EFNA Steering Committee

Meeting Summary

Lacy Road

Fitchburg Community Center to S. Syene Road

PROJECT NO:5849-00-09	HWY:LACY ROAD	COUNTY:DANE	PRELIMINARY IMPACTS	PAGE 5

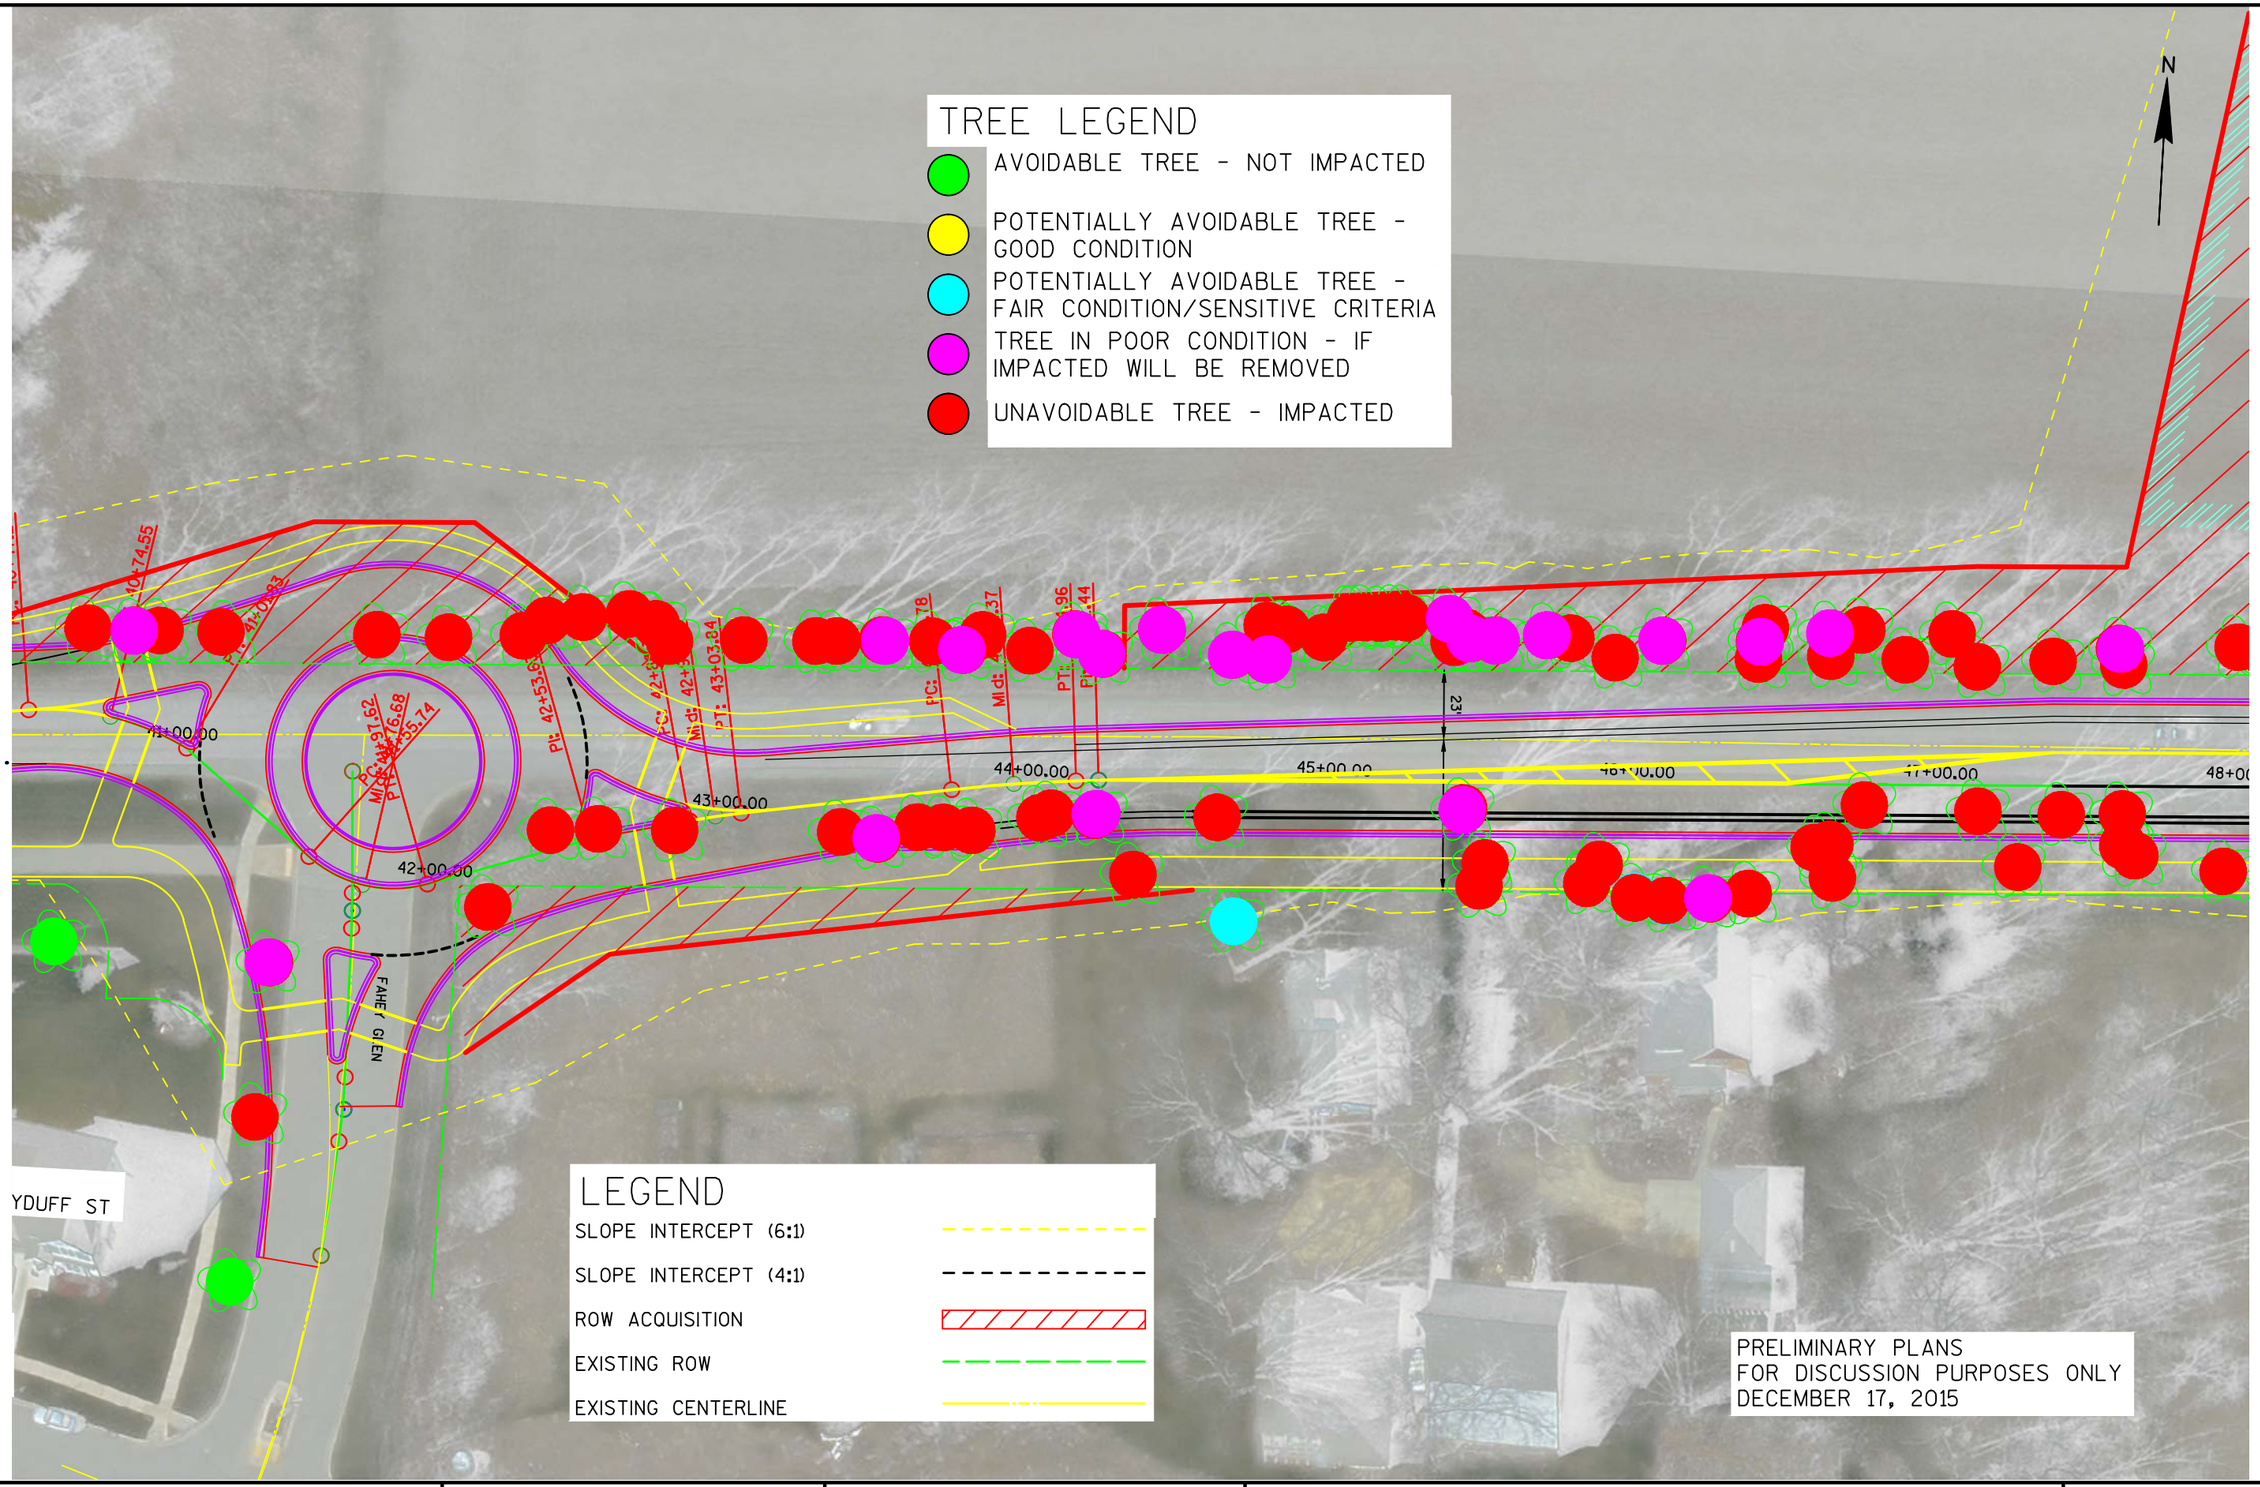
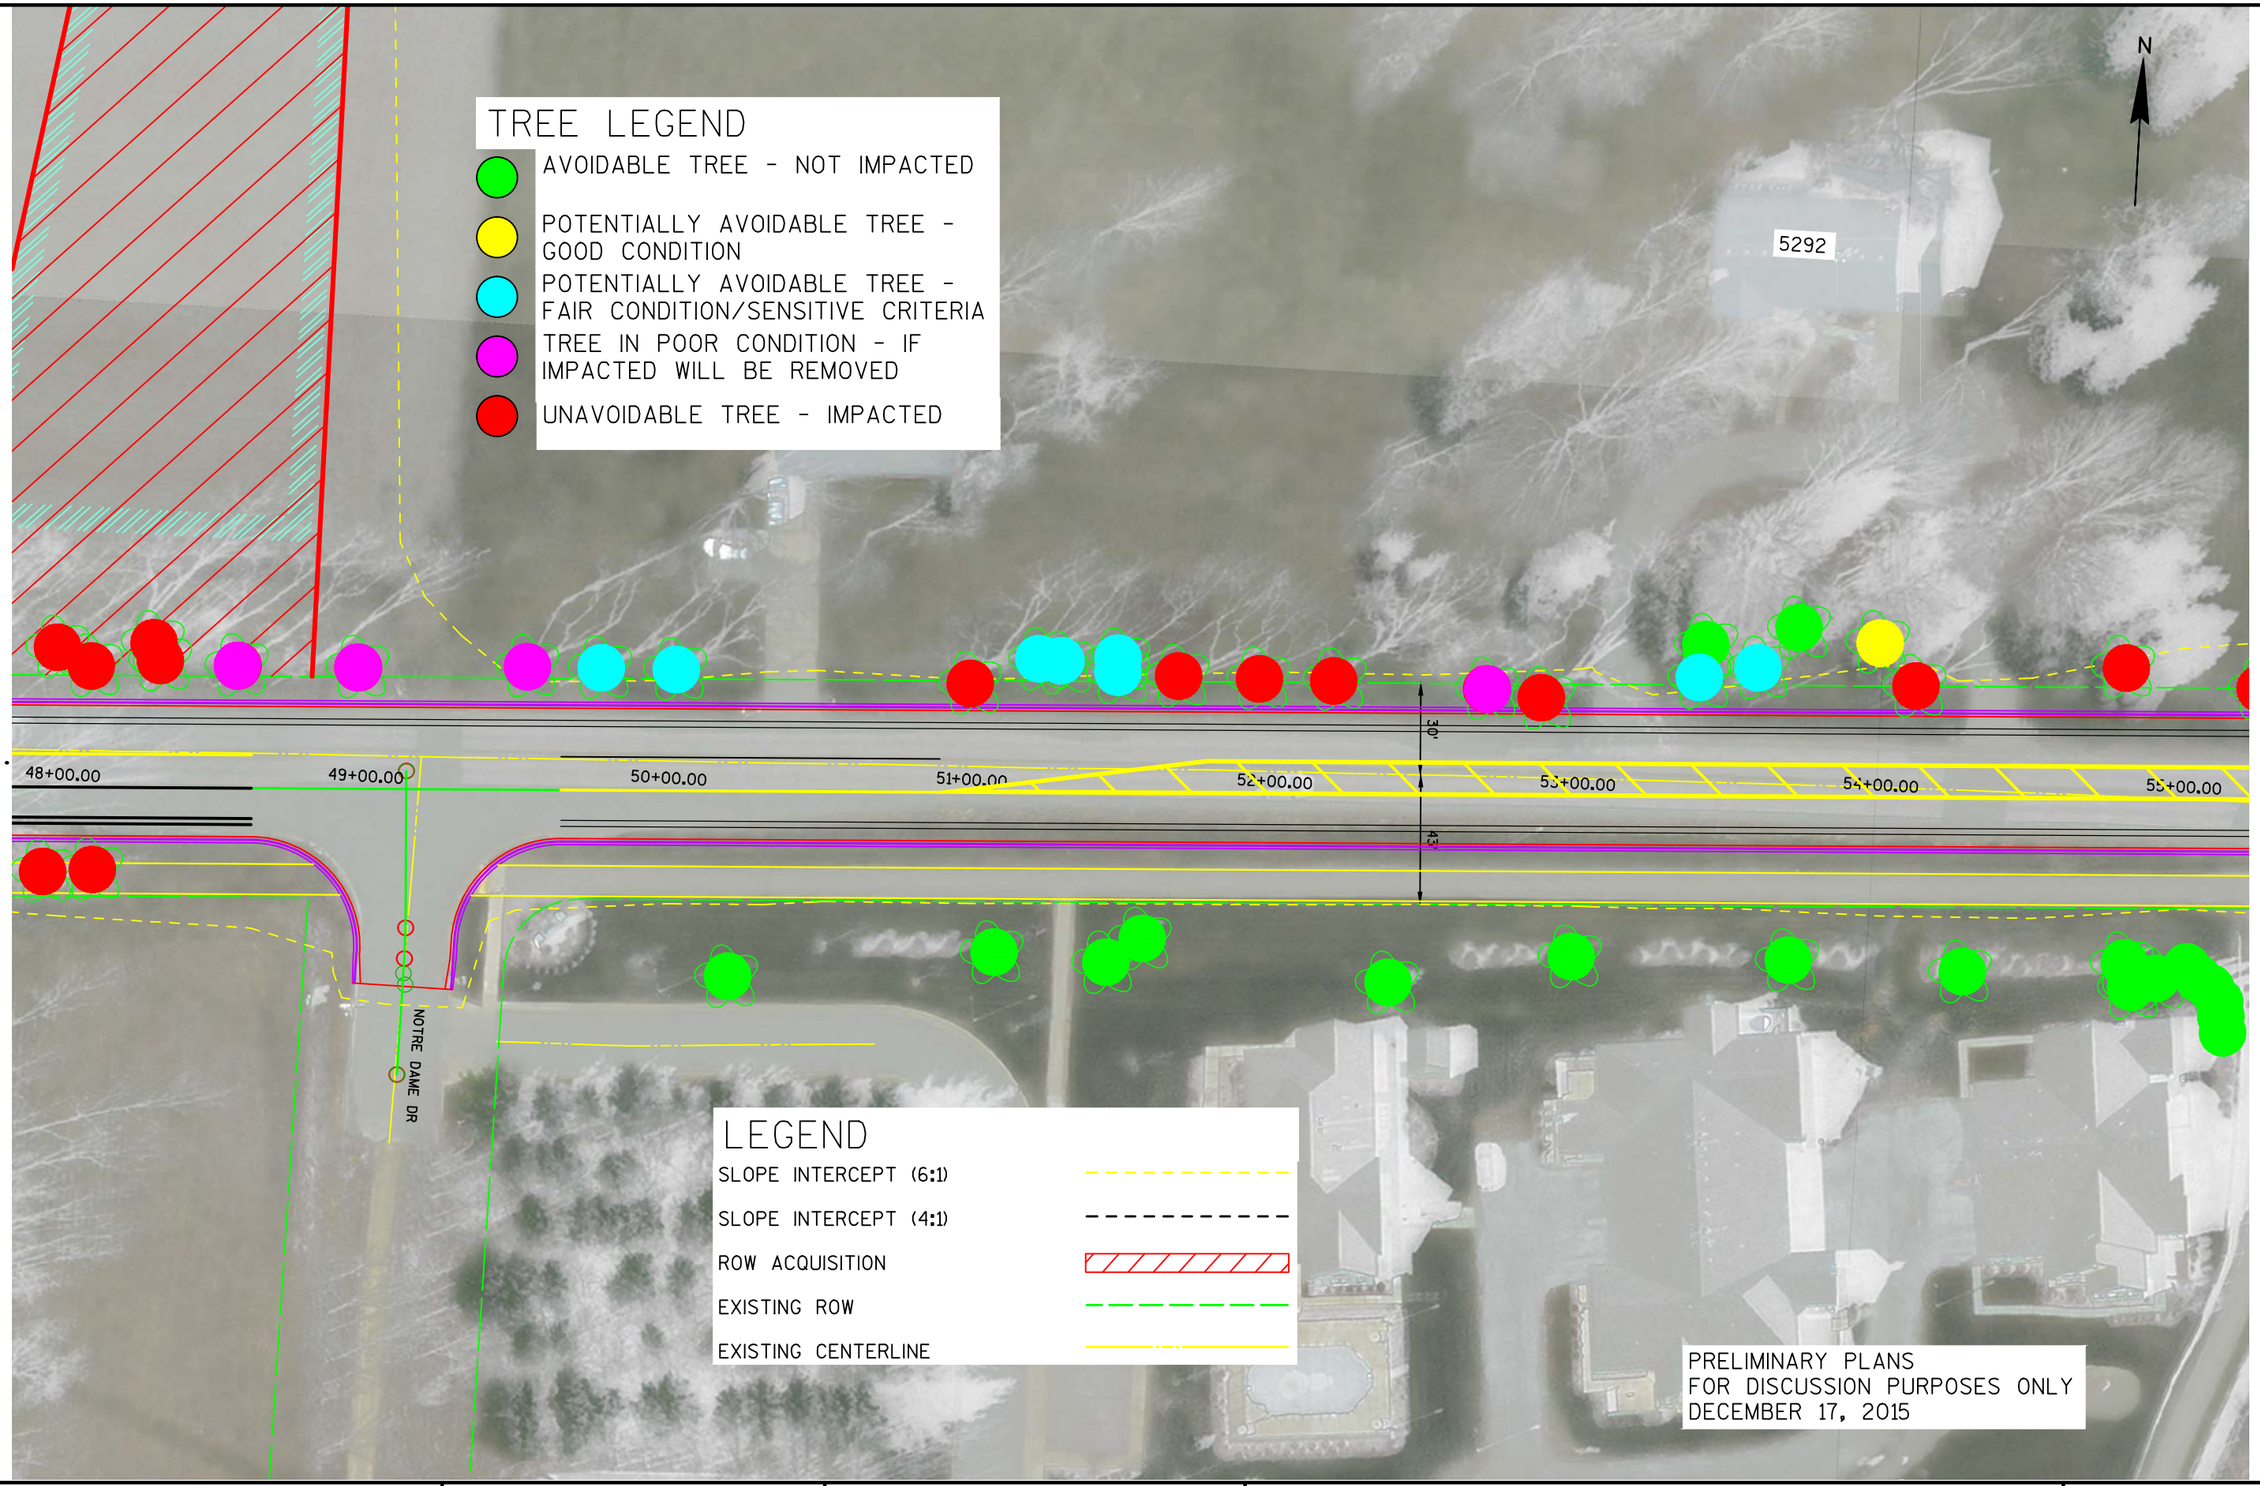
4. Tree evaluation update – Troy provided plans that show each tree along the road. The trees were color-coded to identify "avoidable tree", "potentially avoidable – good condition", "potentially avoidable – fair condition", "potentially avoidable – poor condition", and "unavoidable tree – impacted". These drawings are hot off the press – so additional analysis has not been completed to determine what adjustments would be made to the alignment, terrace width, or path width to potentially avoid tree removals. That is one of the next steps with the design.

PROJECT NO:5849-00-09	HWY:LACY ROAD	COUNTY:DANE	PLAN	SHEET	E

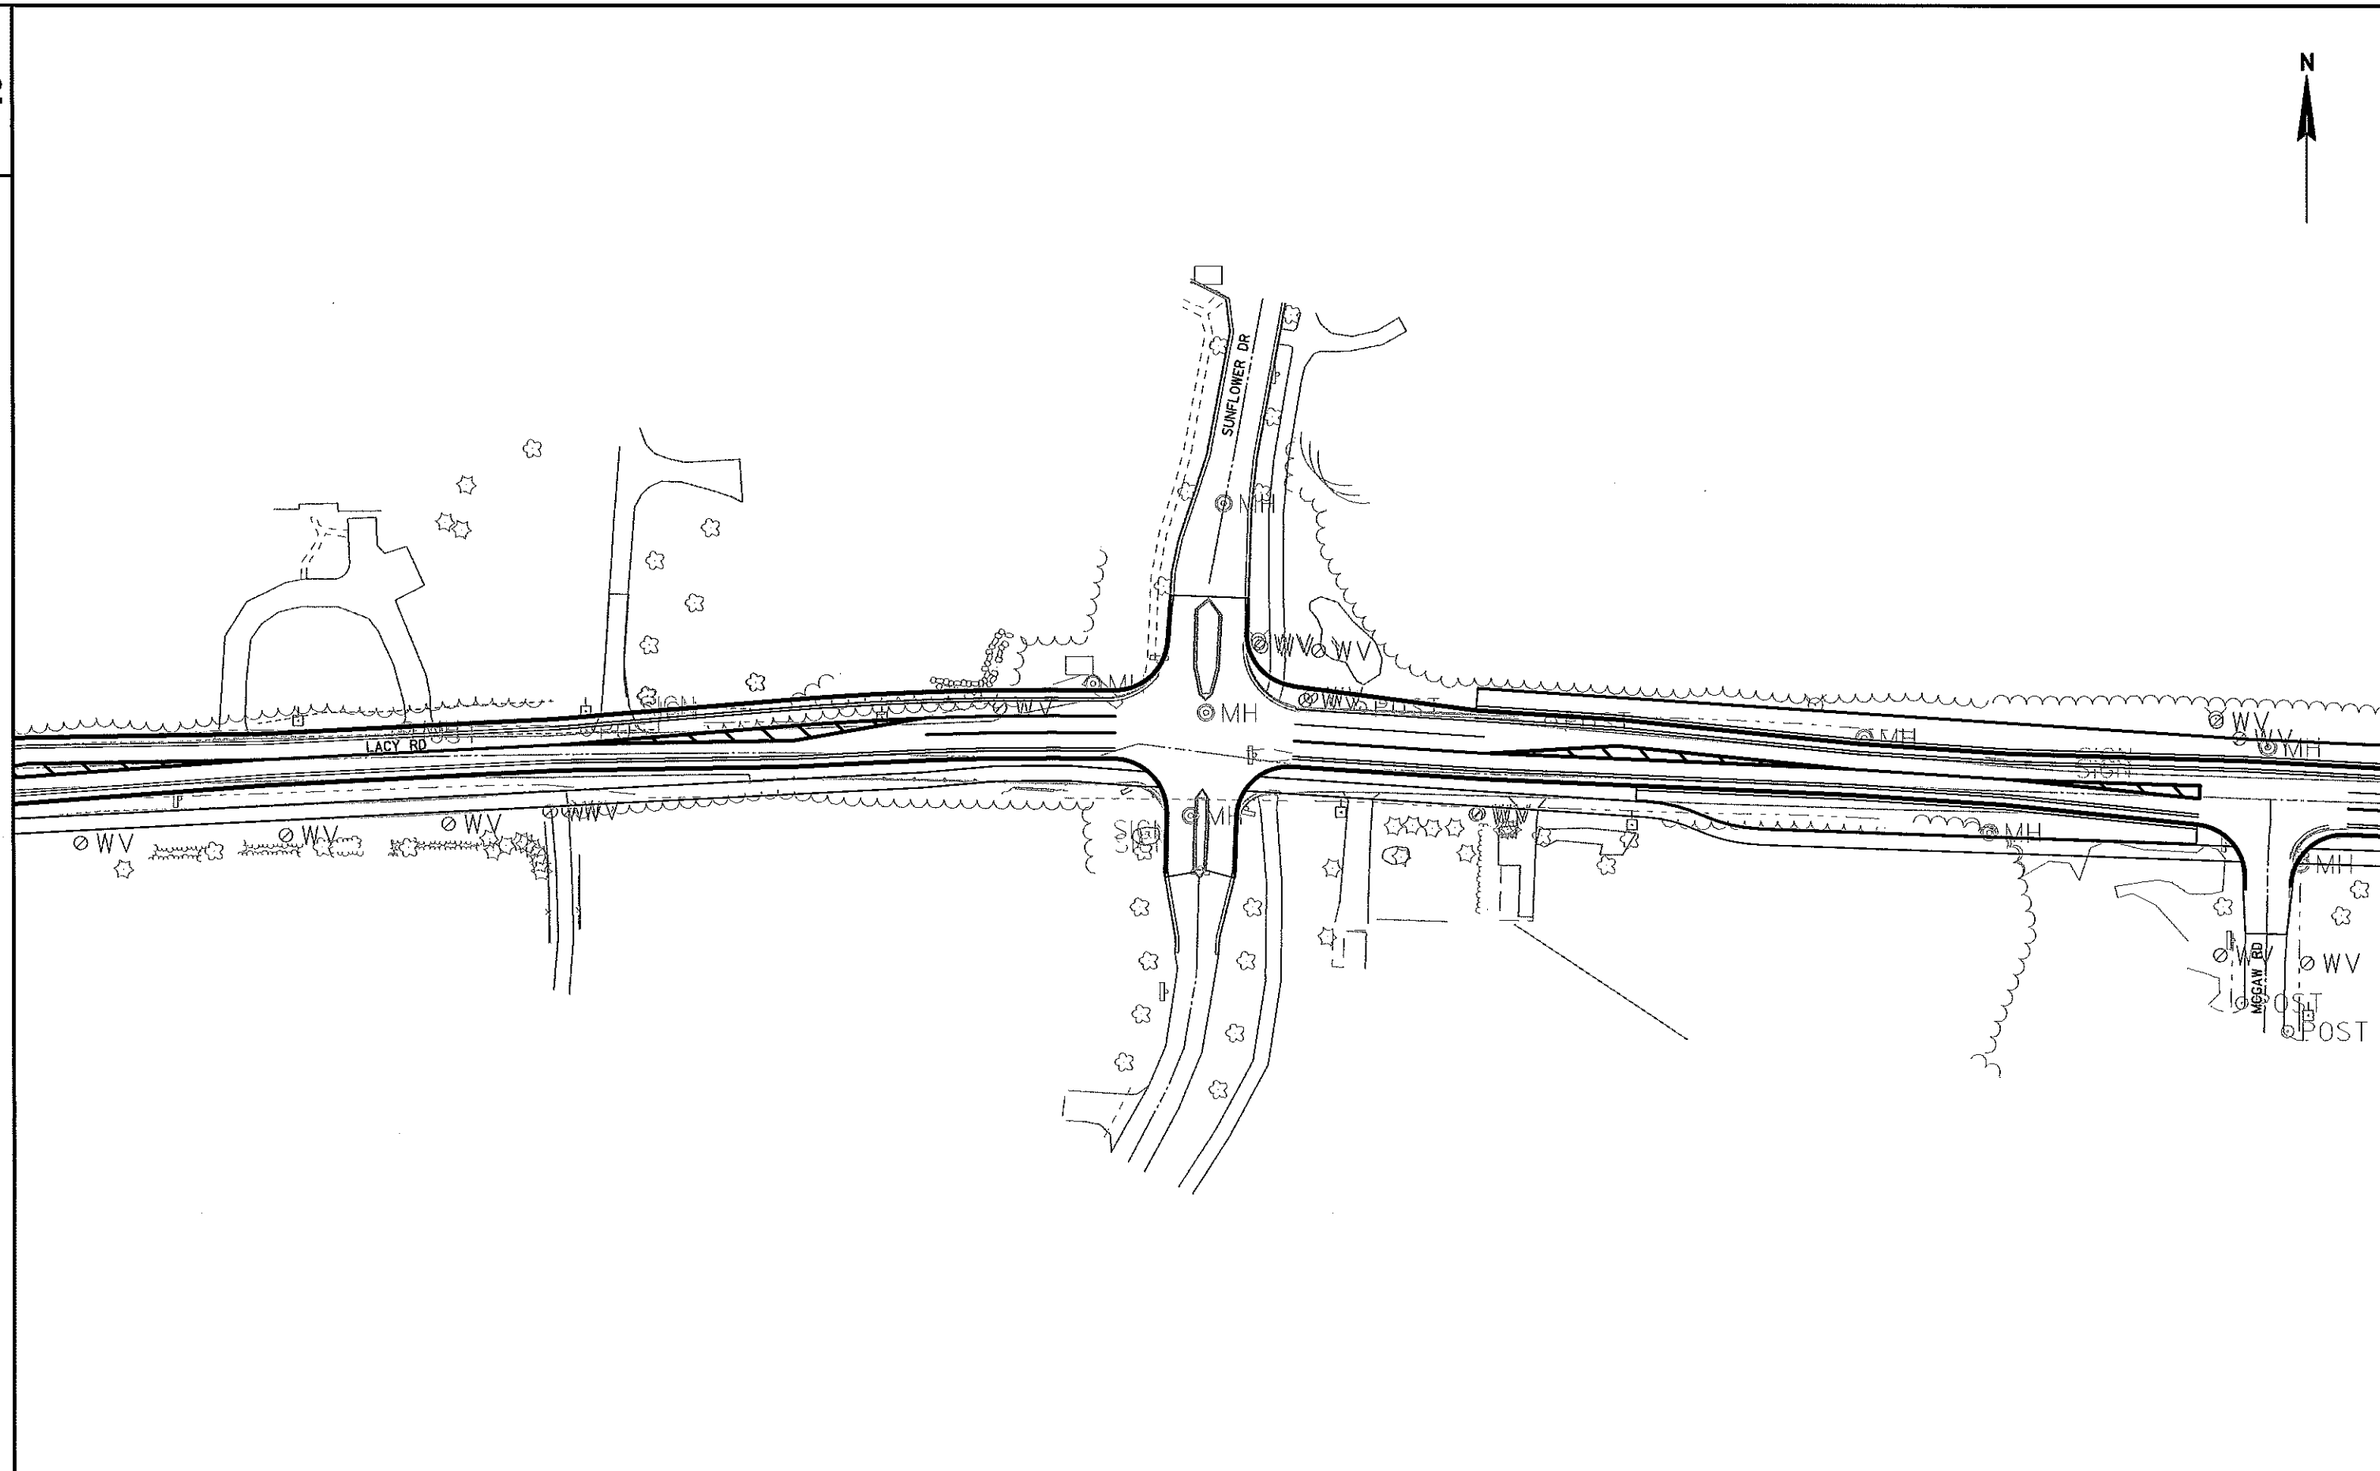
b. Turn lane between Notre Dame/Sunflower and Sunflower/McGaw Road – Troy prepared drawings to illustrate the design without a continuous left-turn lane between the intersections. Staff is still evaluating the drawings to determine which would be the staff recommendation to proceed with.
